Plant:	<u>Nine Mile Point Unit 1</u>		
Date of Event:	<u>9/6/2017</u>		
Submittal Date:	<u></u>		
Licensee Contact:	<u>Rose Demko</u>	Tel/Email:	<u>rose.demko@exeloncorp.com</u>
NRC Contact:	<u>Eric Miller</u>	Tel/Email:	<u>eric.miller@nrc.gov</u>

Unplanned Scrams with Complications

FAQ 20-01
Nine Mile Point Scram

NMP1 Scram 9/6/17 Lo Reactor Water Level

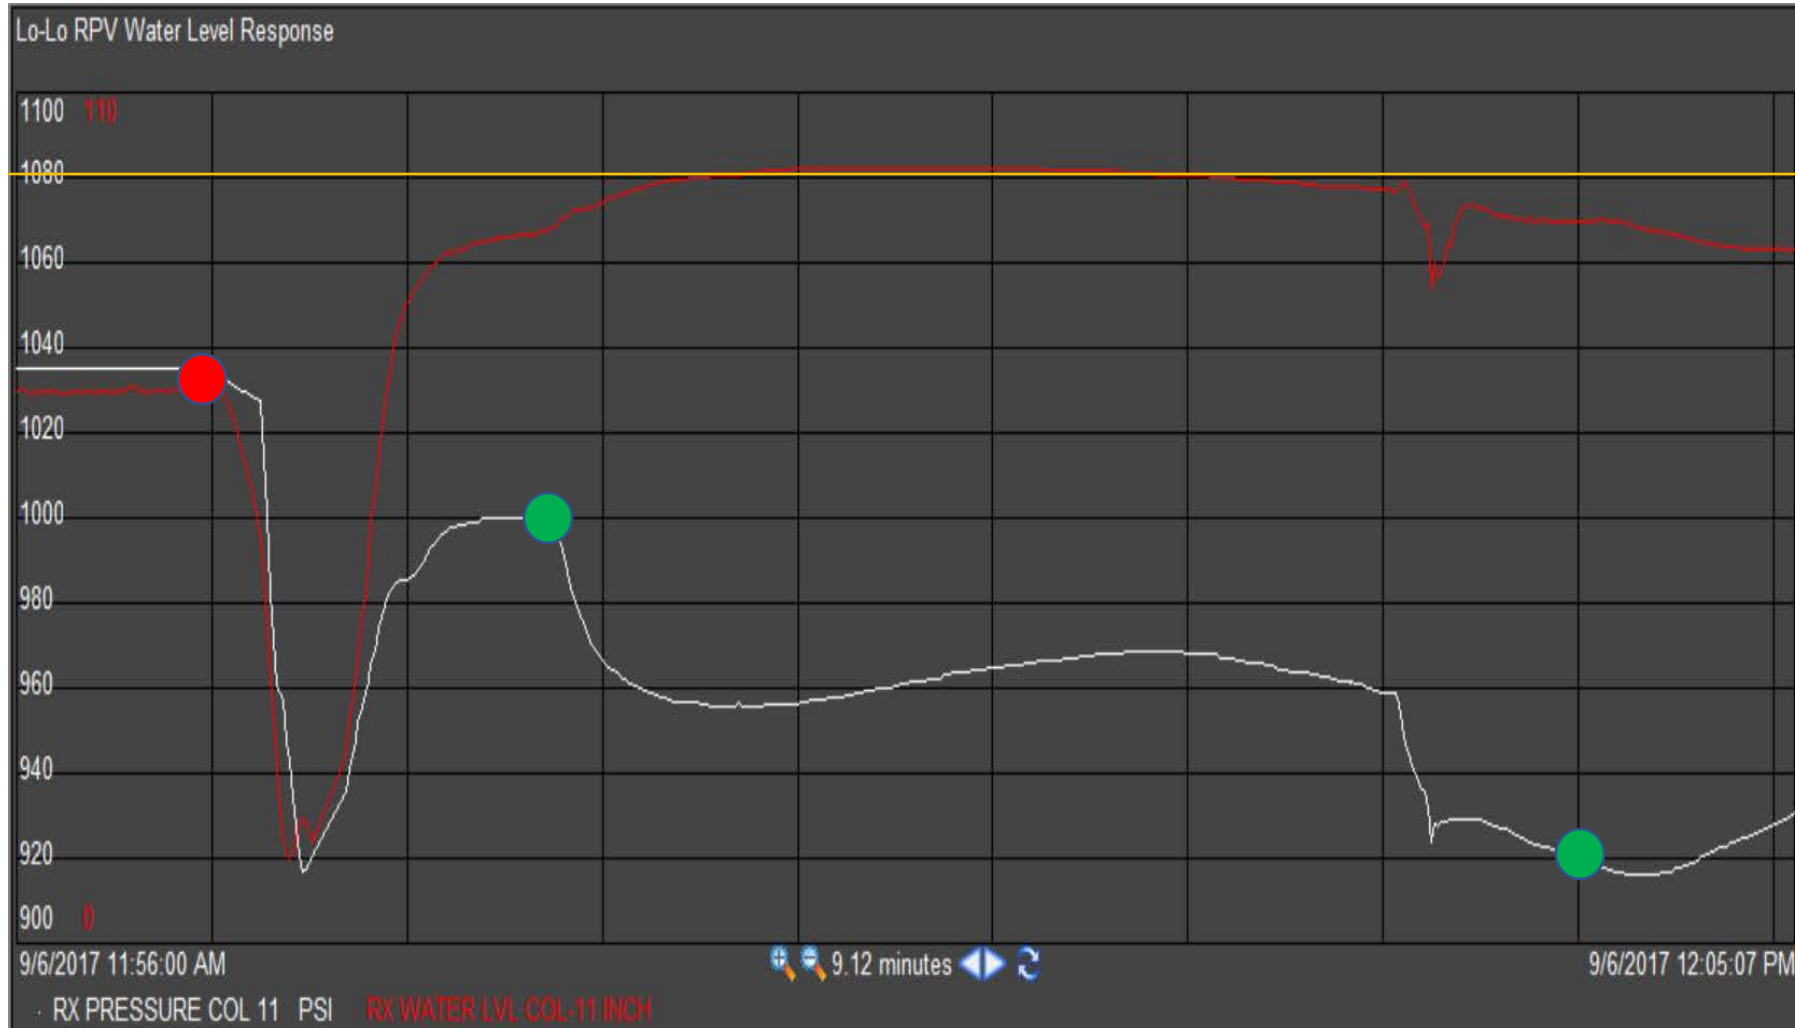
However, operators didn't have TBVs available because Main Steam Isolation Valves (MSIVs) were closed. Instead operators utilized an "alternate pressure control system" listed in N1-EOP-2, the Emergency Condenser (EC). Pressure was controlled using the EC for approximately 8 minutes before the MSIVs were opened and reactor pressure control was re-established using

the TBVs. Therefore, Question 6 should have been 'Yes' in the Unplanned Scram with Complications (USwC) Performance Indicator.

Based on the inspectors' review it appeared that Question 6 should have been answered "Yes," because the ultimate heat sink was lost with main steam isolation valves closed following the initial transient requiring additional time for the use of the alternate pressure control system, emergency condensers, as defined in N1-EOP-2.

The initial Lo RPV Water Level, post scram, was the only EOP entry condition setpoint met during or after the transient. The Lo RPV water level recovered to within normal operating band without Operator Actions as expected. No reactor or drywell pressure EOP entry conditions occurred during or after the transient. The highest pressure in the reactor during the transient

was 1005 psig, well below the EOP entry condition of 1080 psig. No conditions or equipment issues existed during the duration of the scram response requiring re-entry or extended operation in the EOP. Therefore, the answer to this statement is "No."

In conclusion, the use of ECs as an "alternate Pressure Control System," as identified in N1-EOP-2, is a normal reactor trip response. As a result of a low RPV water level scram, at no time during the initial transient and during the scram response did the pressure control system, as described in N1-EOP-2, fail. No additional EOP entries were met after the expected initial entry on Lo RPV Water Level. There was no delay in exiting the EOP and SOP procedures due to the use of EC 11. Therefore, NMP maintains that question #6 is a "No" response.
